NORTH ANNA - UNIT 2

## DISCUSSION OF PROPOSED TECHNICAL SPECIFICATION CHANGES

Figure 6.2-2 Facility Organization - North Anna - Units 1 and 2

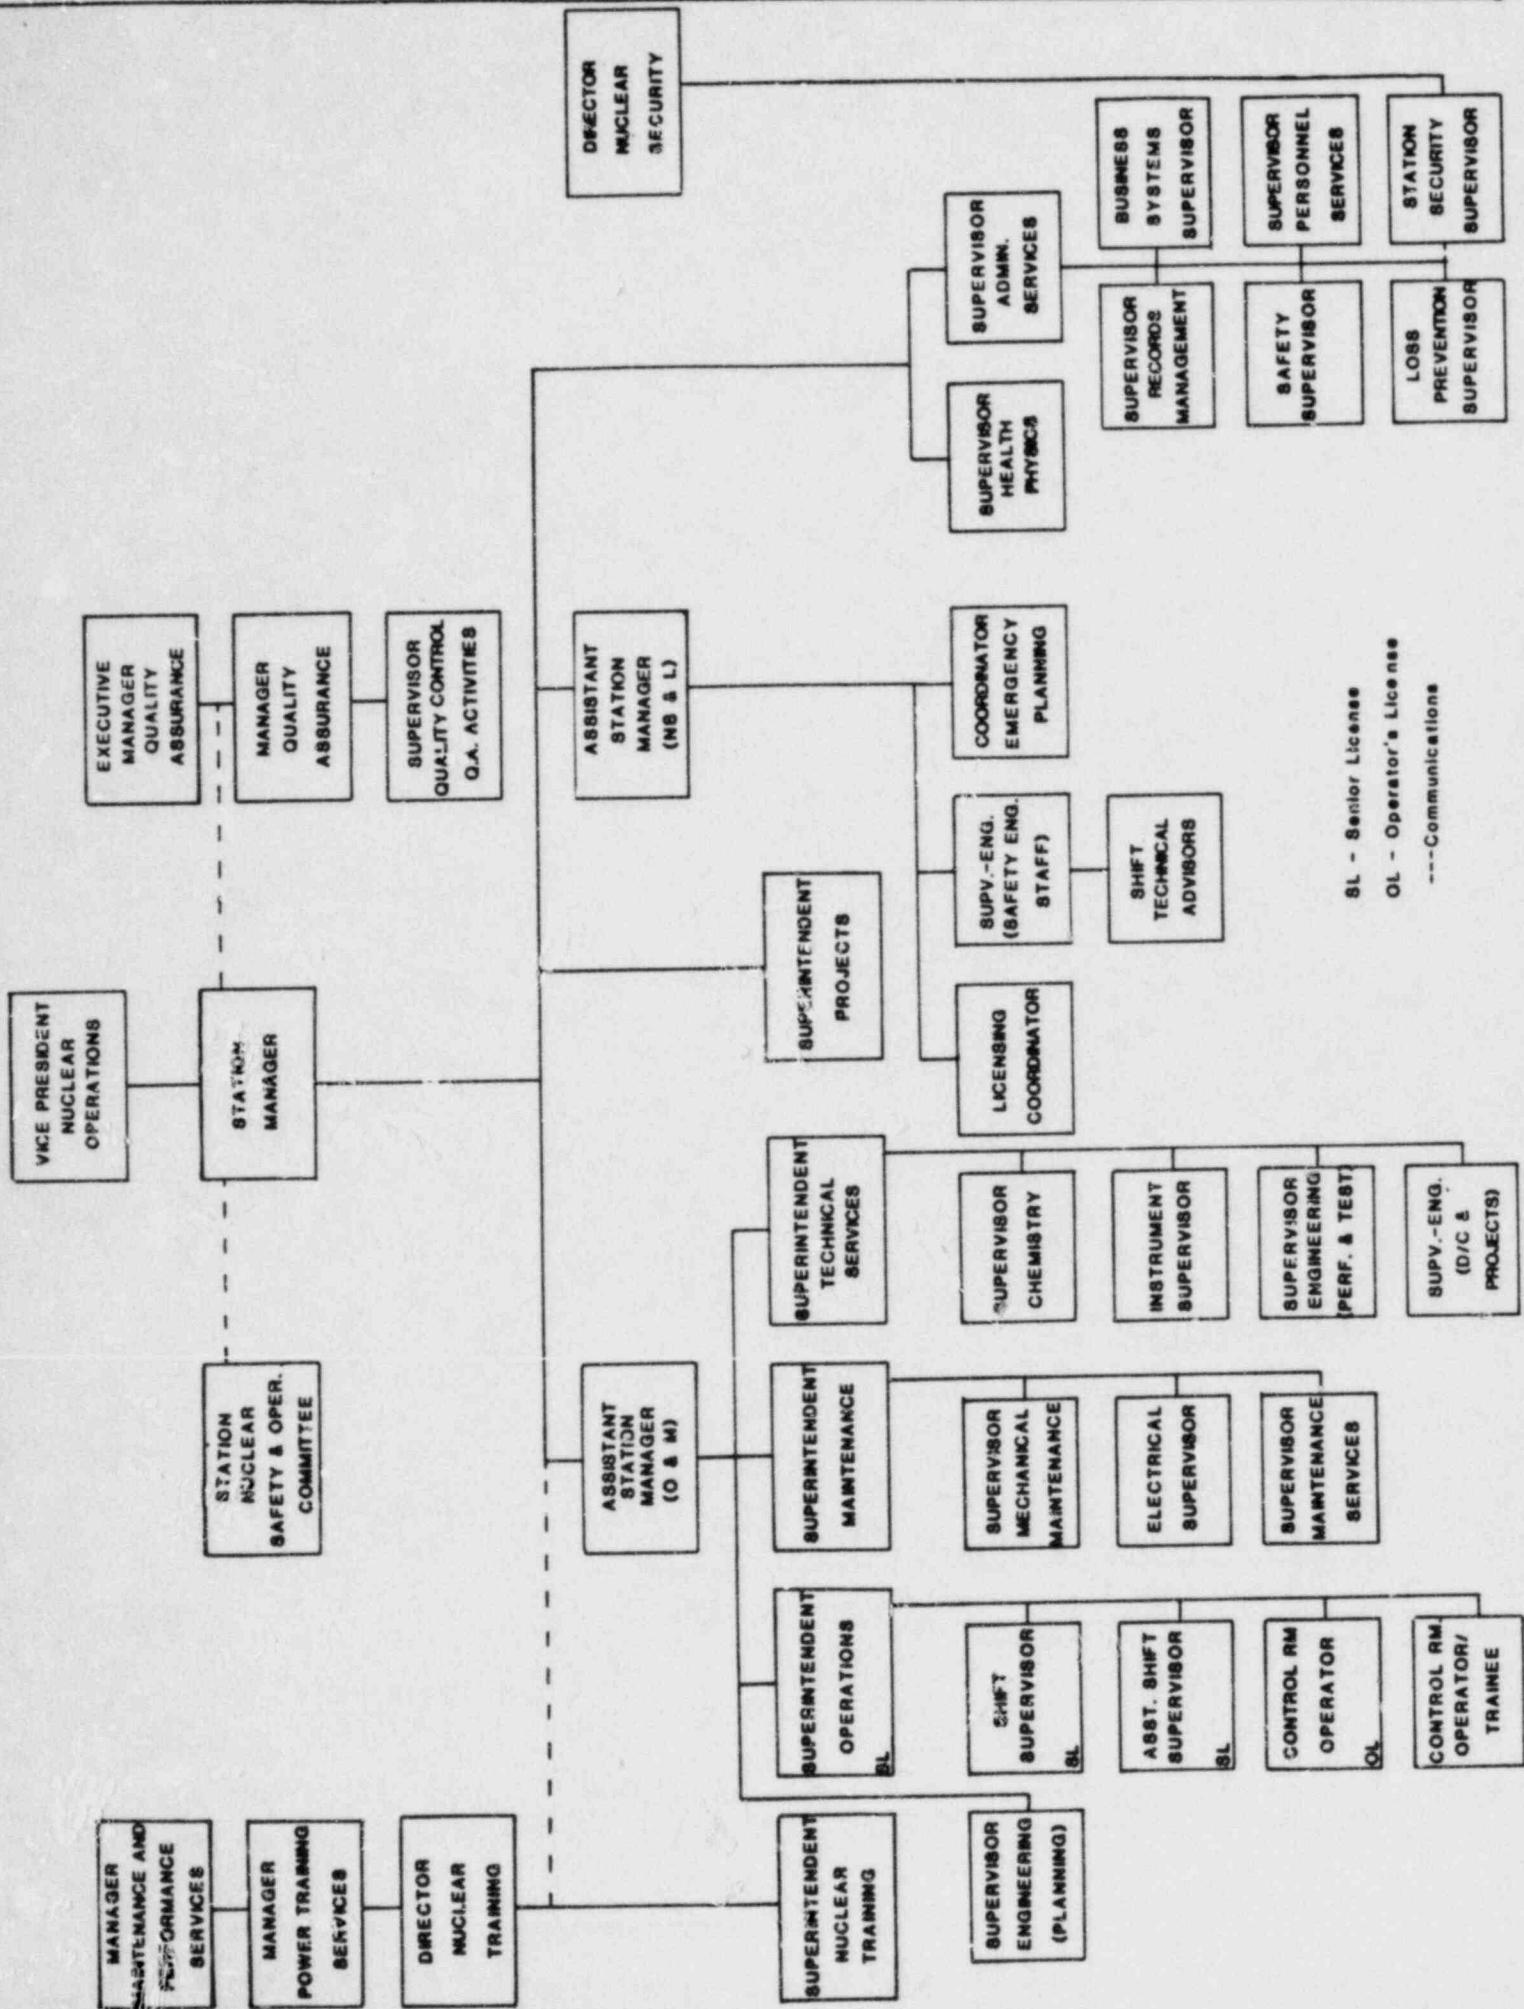
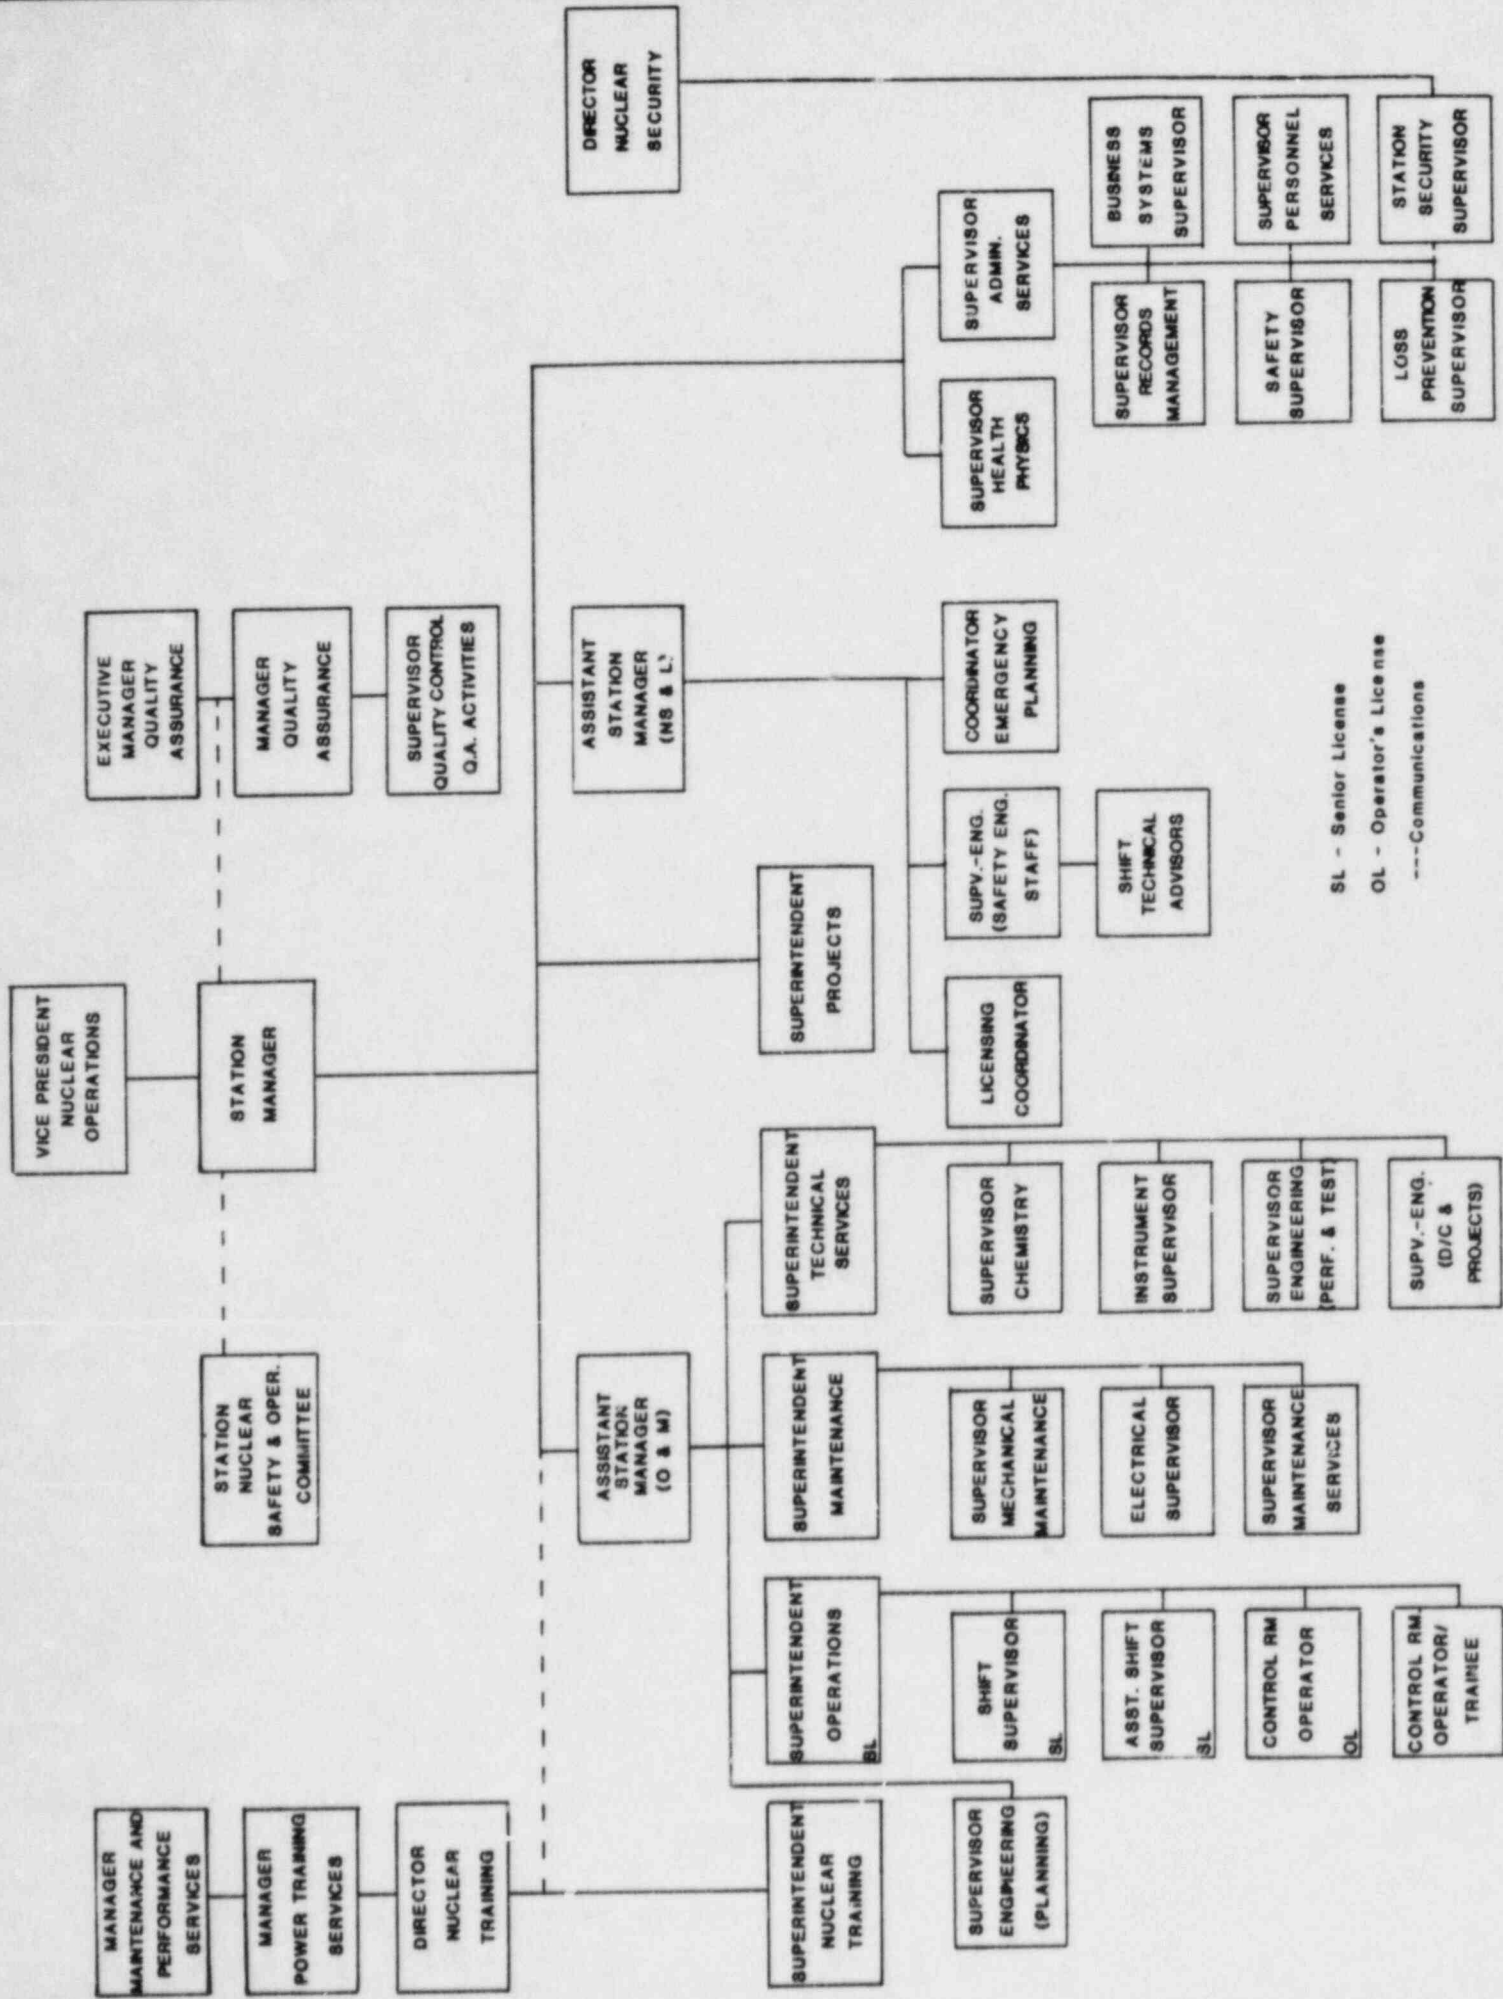
The Superintendent of Projects reports to the Station Manager and is responsible for the management of plant modifications/maintenance activities which are performed as capital projects.

The Coordinator Emergency Planning reports to the Assistant Station Manager (Nuclear Safety and Licensing) and is responsible for implementation of the Emergency Plan at the station and the duties described therein.

The Supervisor - Maintenance Services reports to the Superintendent Maintenance. He is responsible for evaluating maintenance procedures and methods to ensure compliance with regulatory requirements and company policy, developing a maintenance management program for preventive and scheduled routine maintenance, developing and monitoring a spare and replacement parts program, developing plans for impending outages, and recommending requirements for new and revised maintenance training programs.

The Supervisor Engineering (Performance and Testing) reports to the Superintendent Technical Services and is responsible for providing engineering technical support for station operations, administering the periodic test program to insure compliance with the Technical Specifications, optimizing plant performance, and providing continuous technical evaluation of reactor operation.

The Supervisor Engineering (D/C and Projects) reports to the Superintendent-Technical Services and is responsible for providing the administrative control and technical evaluation of all station modifications and design changes.

The Supervisor Engineering (Planning) reports to the Assistant Station Manager (Operations and Maintenance) and is responsible for the preparation and administration of schedules for all maintenance and design change activities during unit outages.
